MOORE PUBLIC SCHOOLS -
OLD SCHOOL REPLACEMENT
Moore Public Schools - Moore, Oklahoma
AGP - Moore, Oklahoma

ADDENDUM NO. 2
April 14, 2026

A201

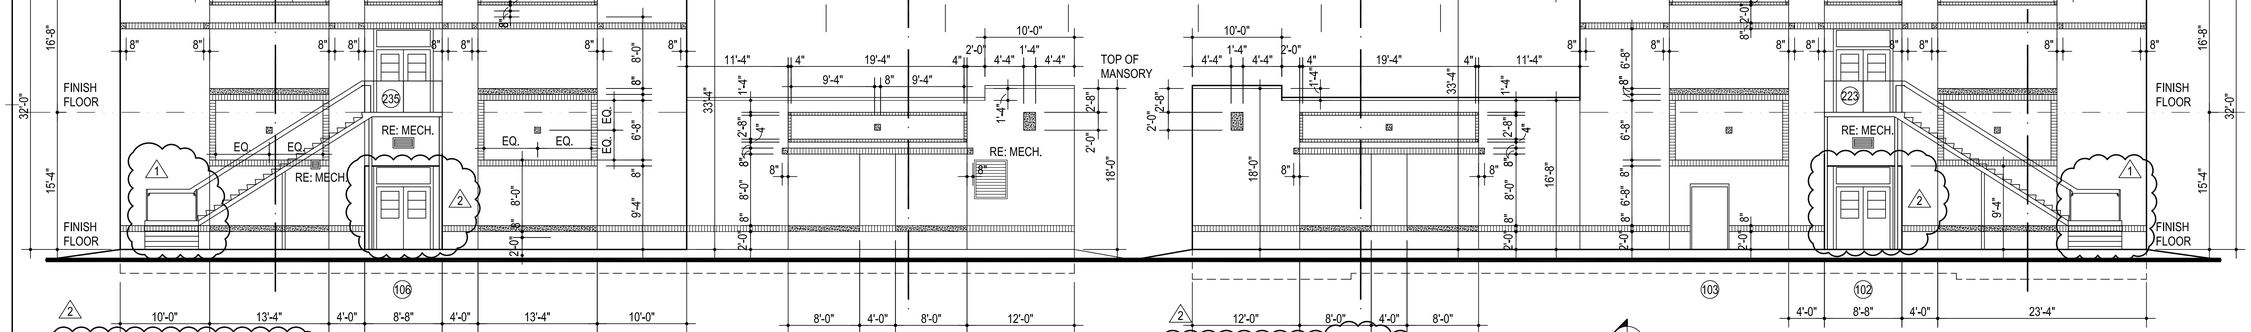
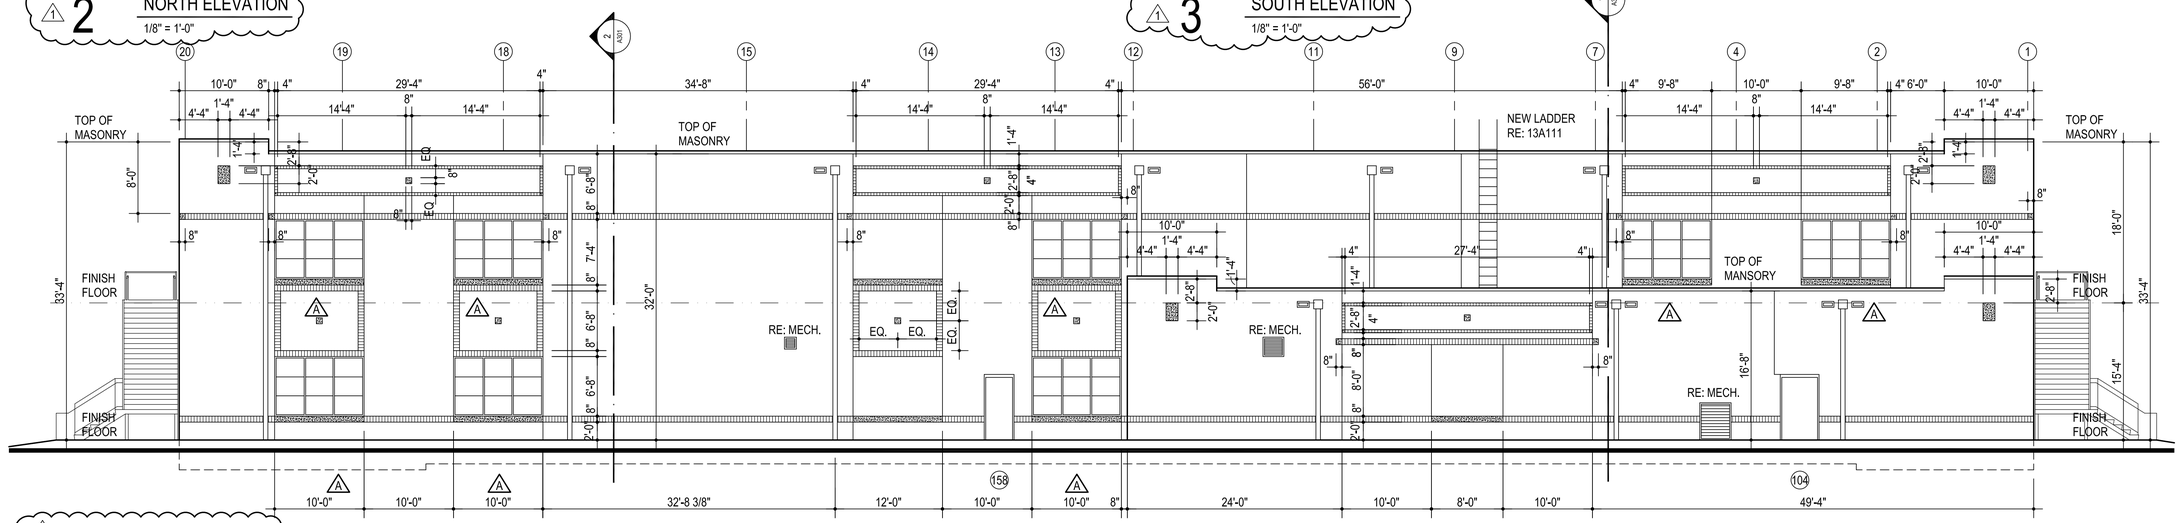
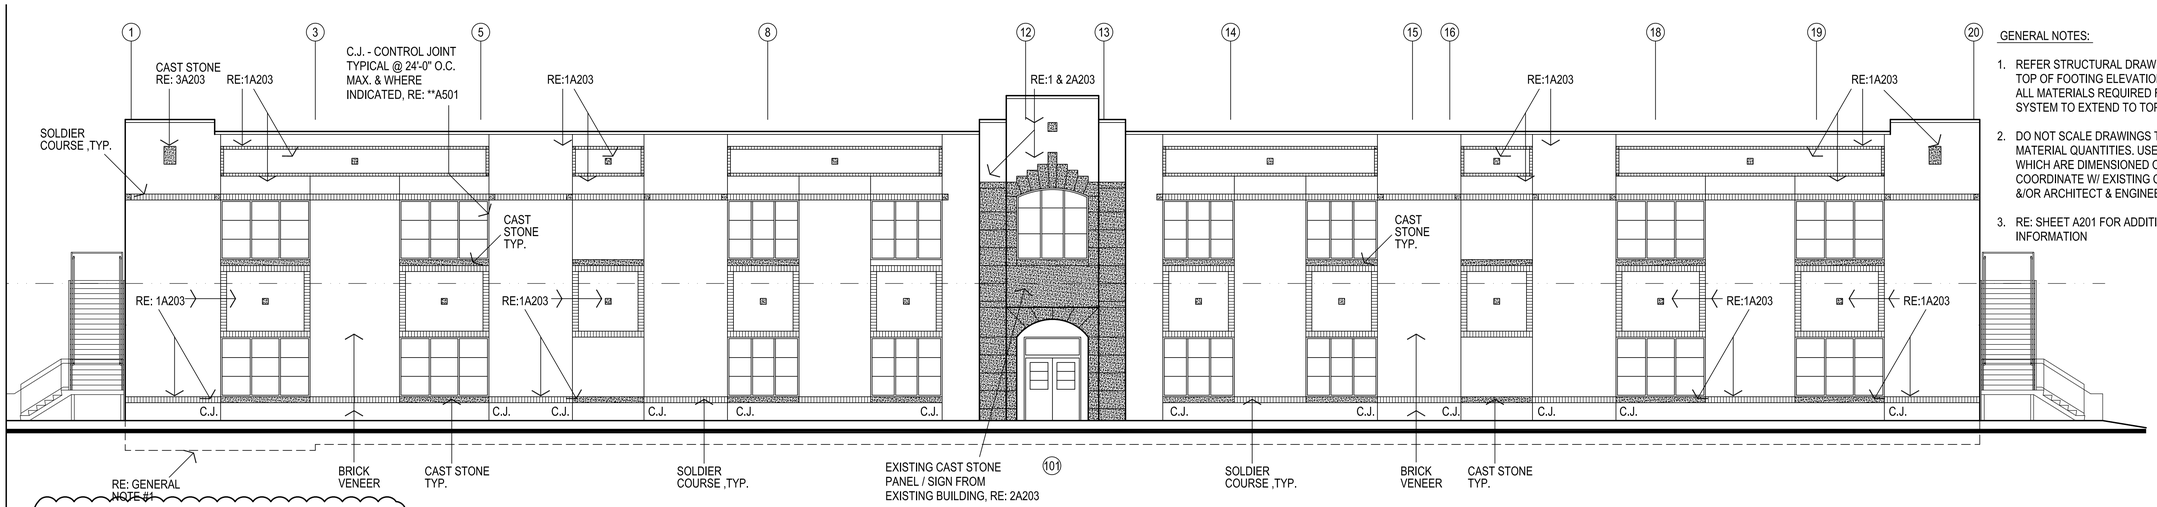
6. Sheet A201, Exterior Elevations / Sheet A202, Exterior Elevations / Sheet A203, Details #1, 2, & 3, Exterior Elevations – Materials / Sheet A204, Detail #1, North / South Elevations: revised exterior elevations to reflect changes / updates to brick and cast stone dimensions. Refer to attached revised drawings.

A301

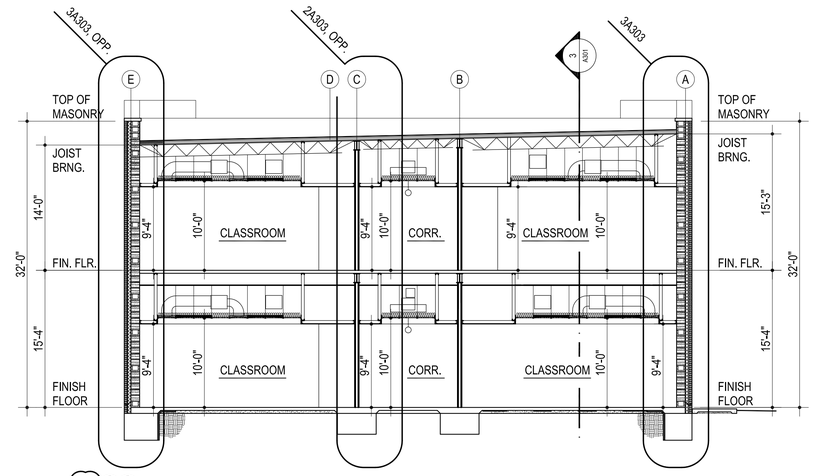
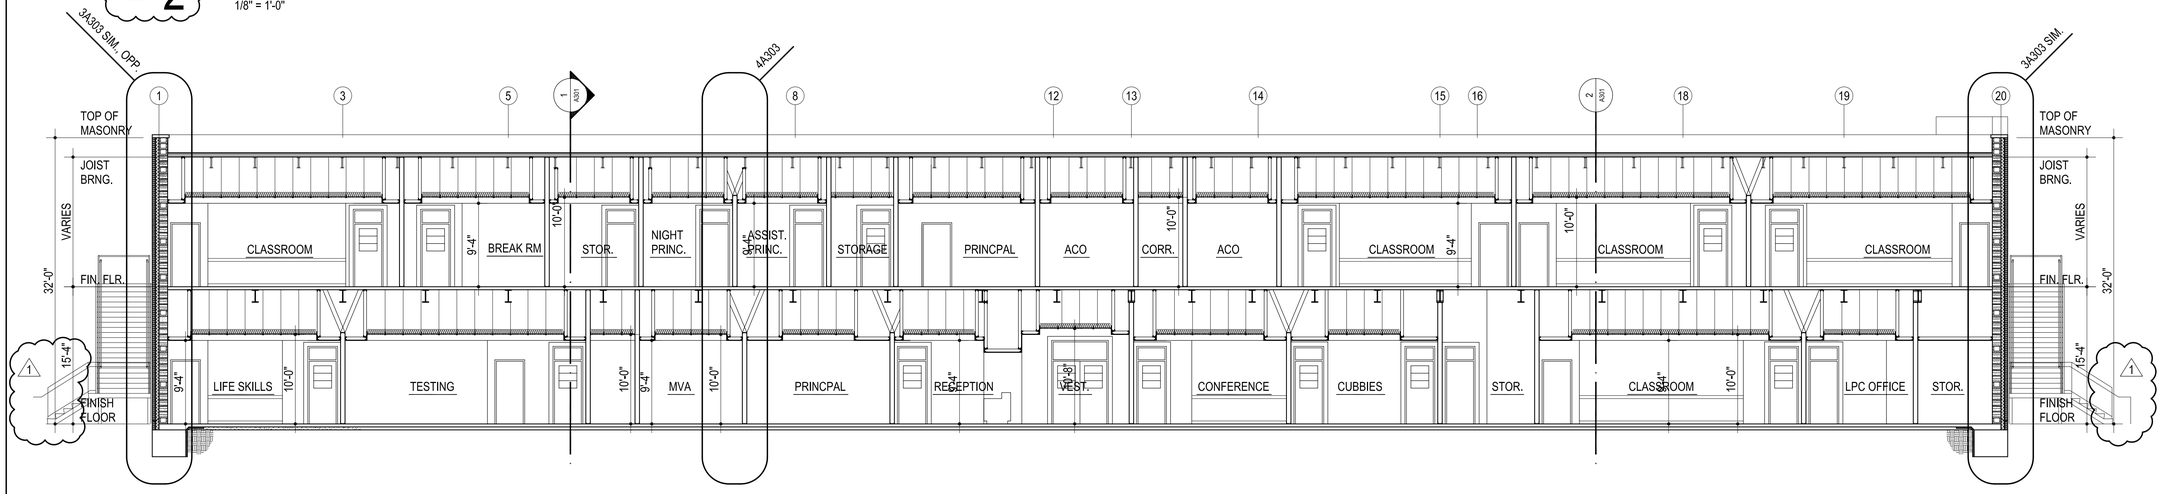
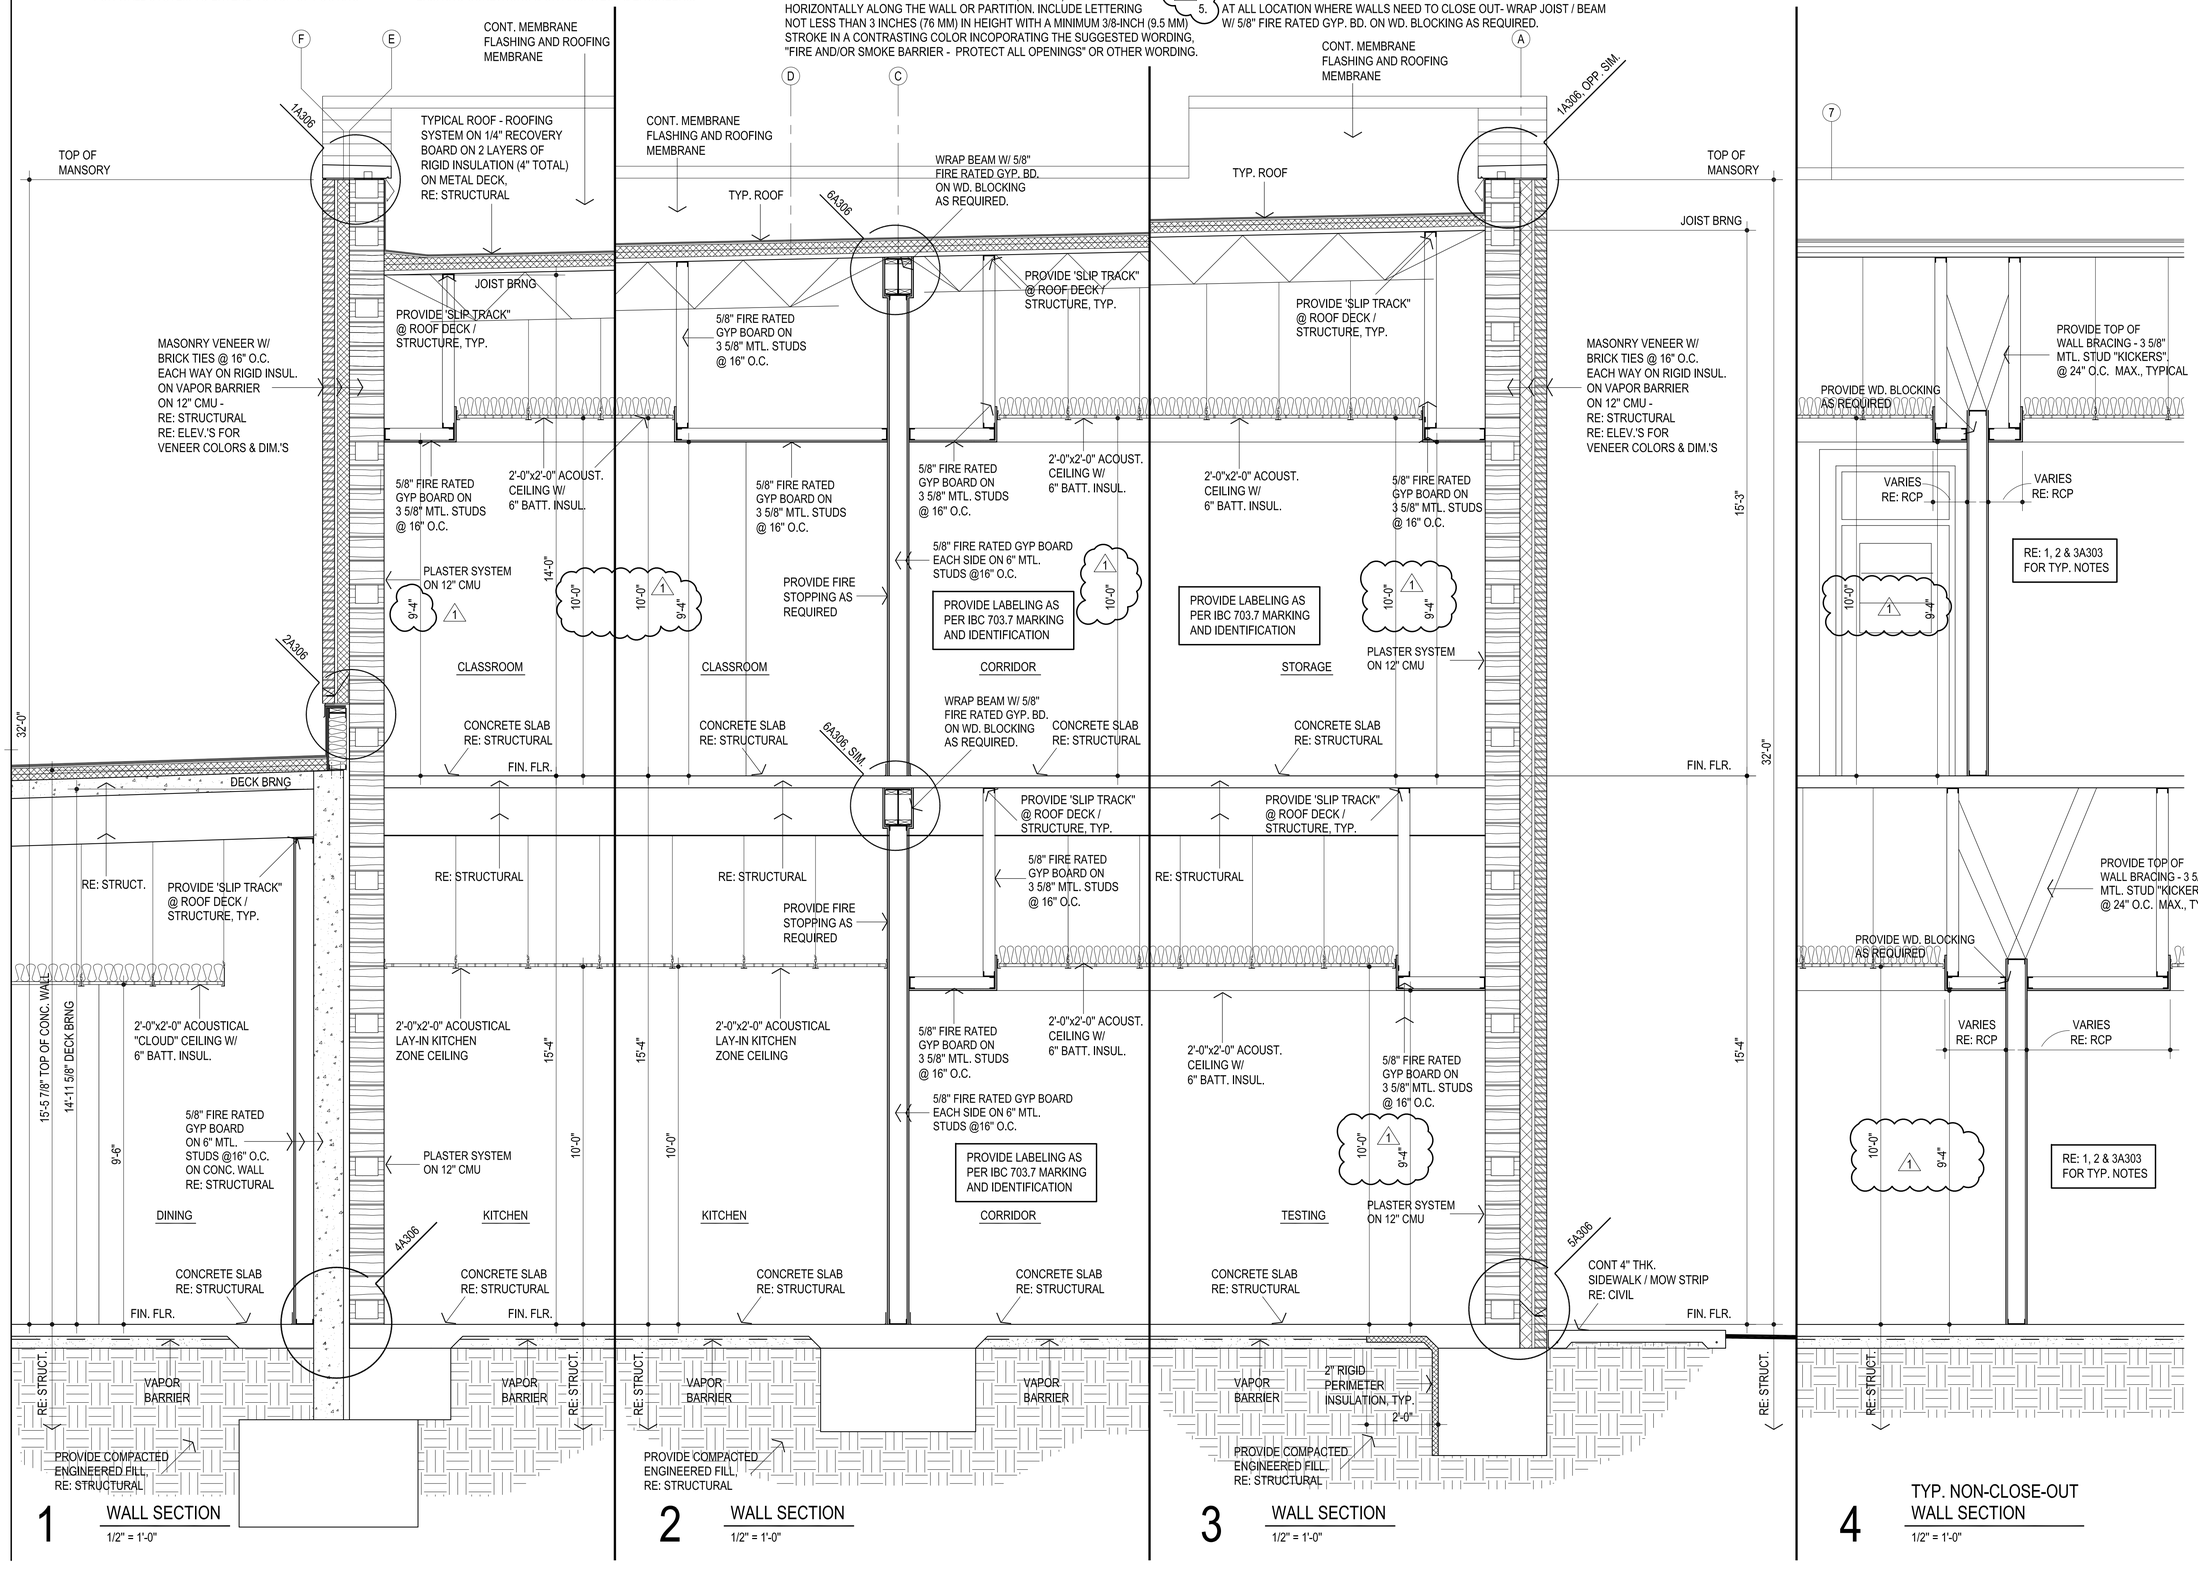
7. Sheet A301, Details #1, 2, & 3, Building Sections: revised building sections to reflect changes in ceiling heights. Refer to attached revised drawing.
